**NUMBER:** 18-004-06 REV. A

Flash - No Start Or Hard Start

This bulletin involves replacing the Idle Air Control Motor (IAC) and selectively erasing and reprogramming the Powertrain Control Module (PCM) with new software.

**\*\*2004 - 2006\*\*** (CS) Pacifica

**Fig. 1 AUTHORIZED MODIFICATION LABEL**

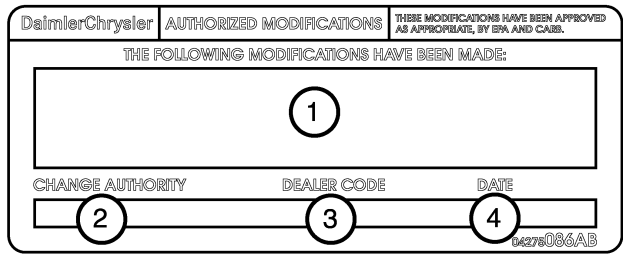
14. Type the necessary information on the "Authorized Modification Label" p/n 04275086AB and attach near the VECI label ([Fig. 1](#)).

- 1 - POWERTRAIN CONTROL MODULE P/N (INSERT P/N) USED
- 2 - CHANGE AUTHORITY: TSB XX-XXX-XX
- 3 - DEALER CODE: XXXXX
- 4 - DATE: XX-XX-XX
